**ITEM FOR ENVIRONMENTAL COMMISSION AGENDA**

NAME & NUMBER OF PROJECT: BKO Parmer (SP-2021-0034D)

REQUEST: Variance request is as follows:
Request to vary from LDC 25-8-342 to allow fill over 4feet up to 12feet.

Development Services Department
Staff Recommendations Concerning Required Findings

CUT FILL EXHIBIT

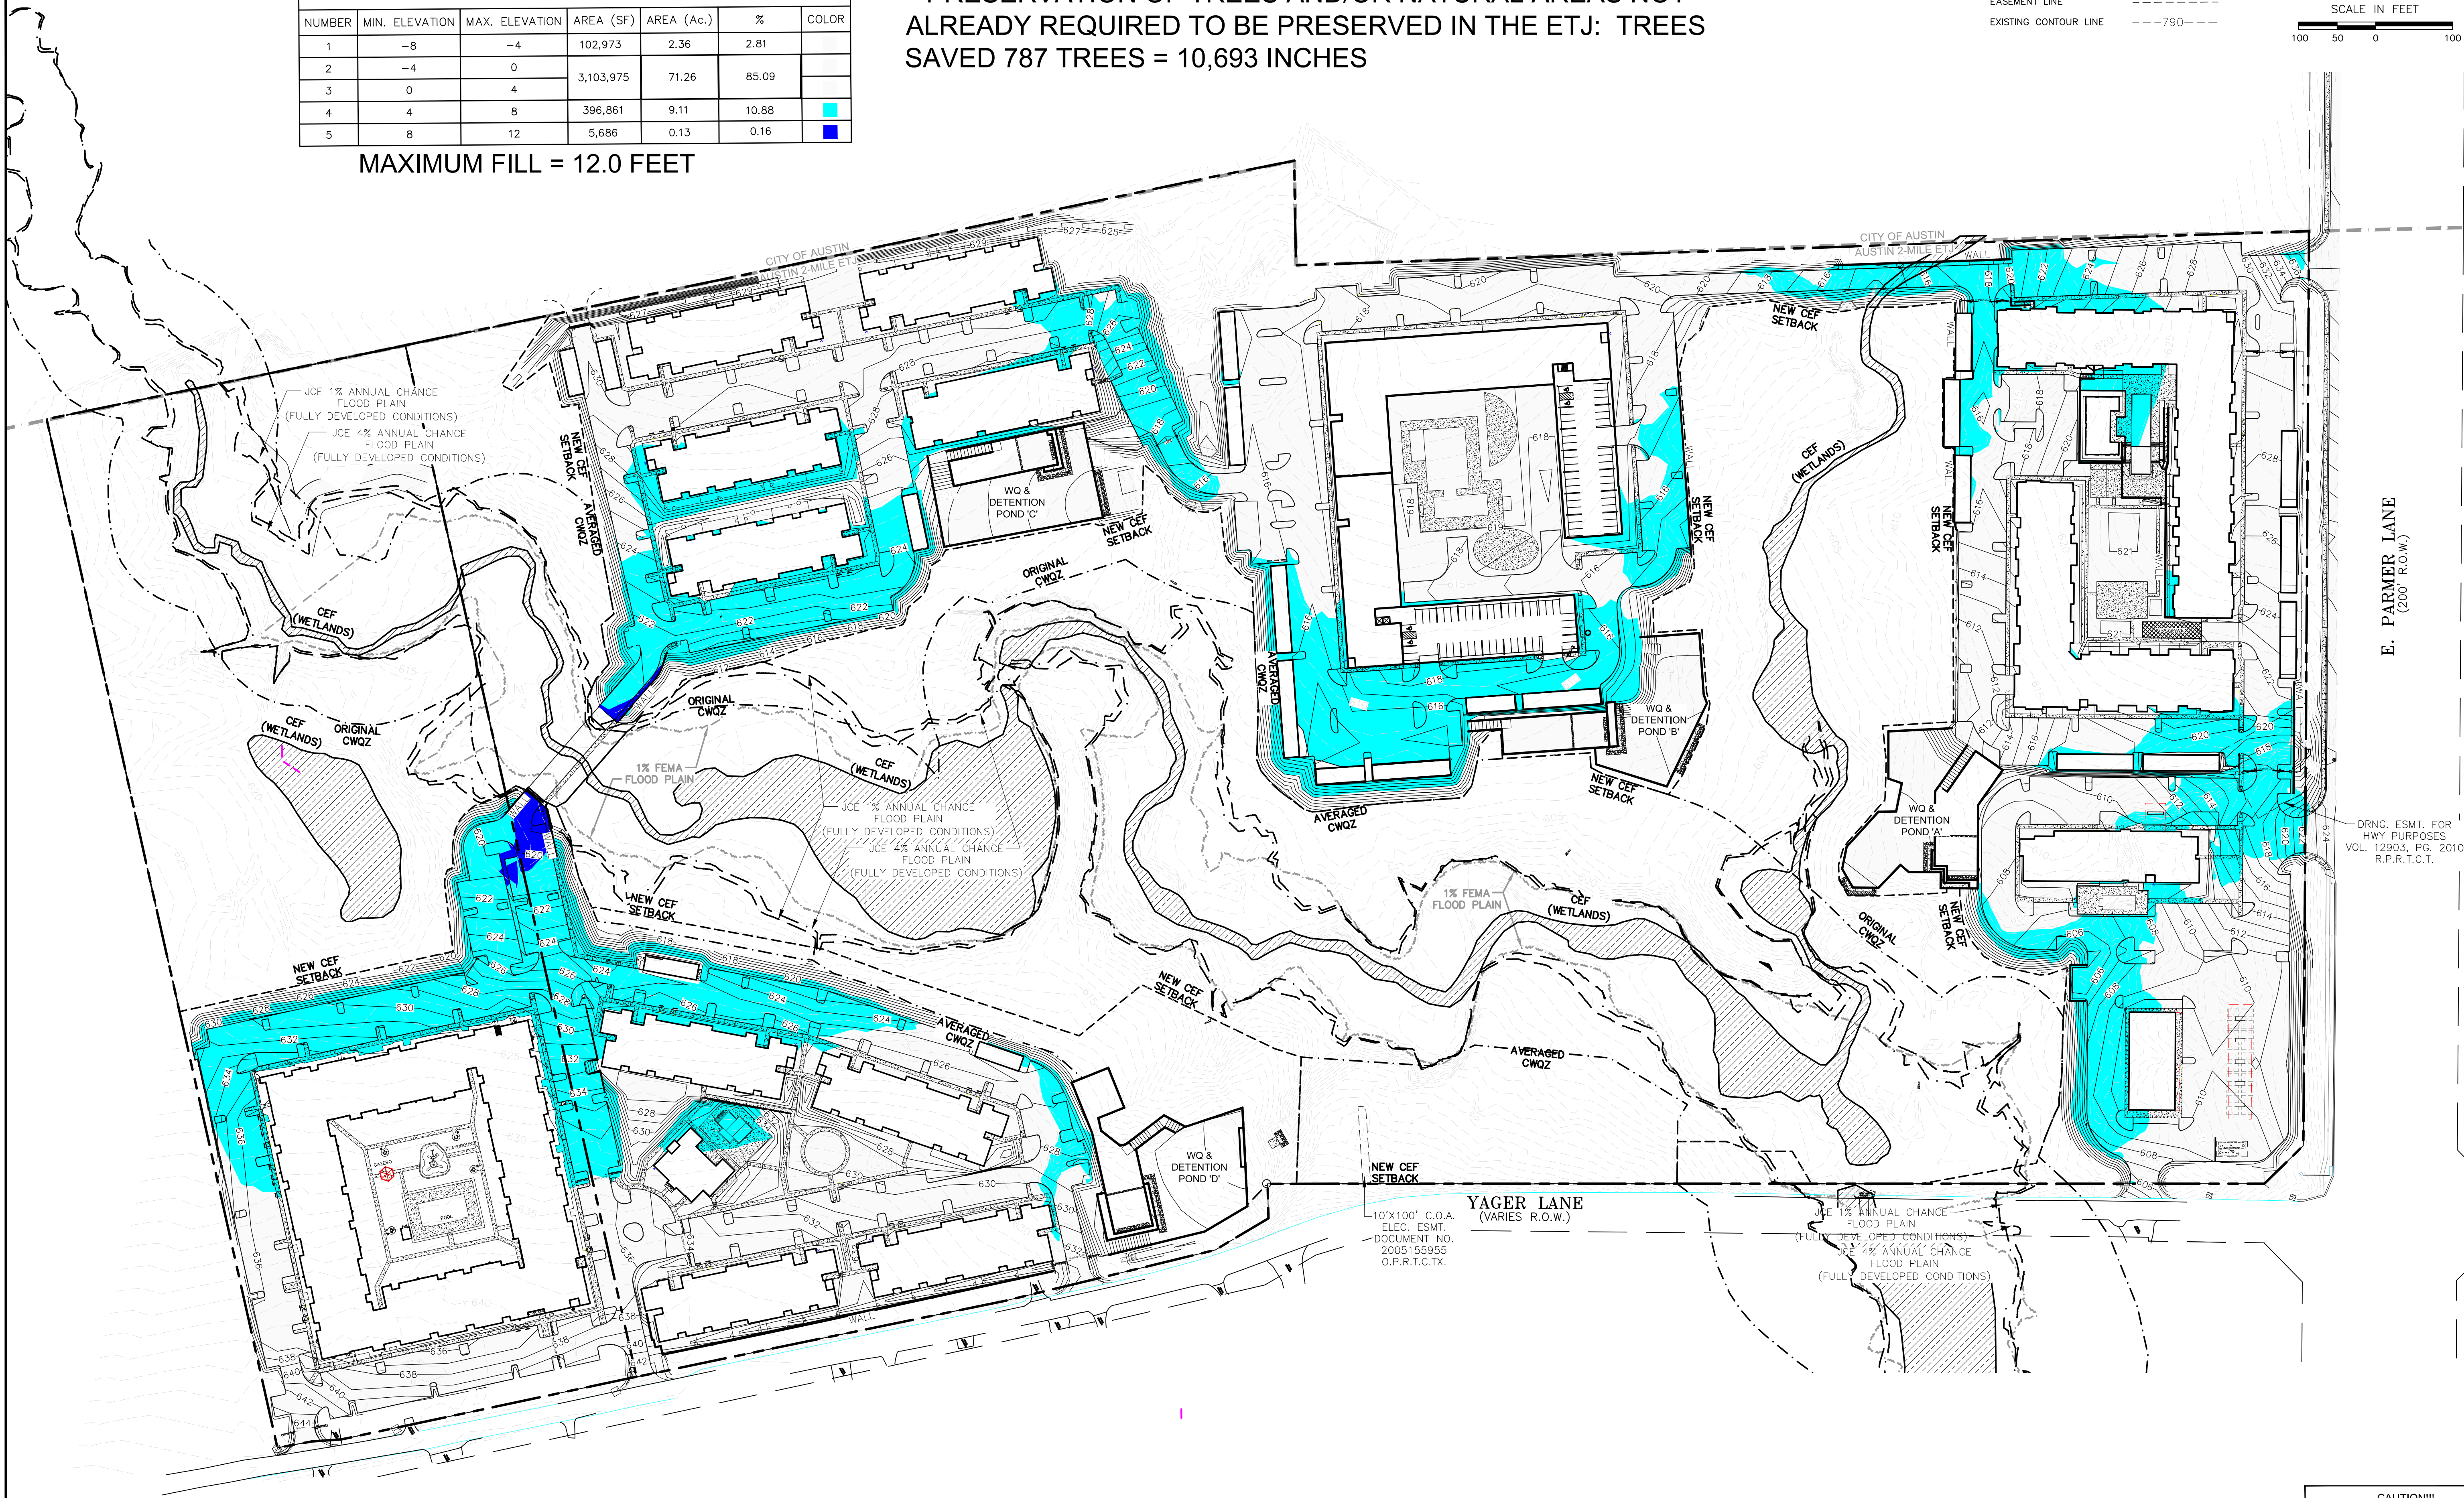
- Preserve trees/natural areas.
- Apply City of Austin Landscaping Ordinance on ETJ site.
- Provide structural containment of fill with a retaining wall.

Yes. The variance will not be providing a special privilege to the applicant. The proposed buildings are similar in size to similarly situated property. In order to facilitate this type of development levelling and additional fill is required for the buildings.

Yes. Existing site conditions necessitate additional “fill” for fulfilling the requirements of two fire lane/emergency access routes as well as structural bridge for spanning the CWQZ.

Yes. The variance does not create a significant probability of harmful consequences. The variance is a minimum deviation from code to allow for reasonable use of the property. Fill will be minimized and structurally contained with a retaining wall.

MAXIMUM FILL = 12.0 FEET
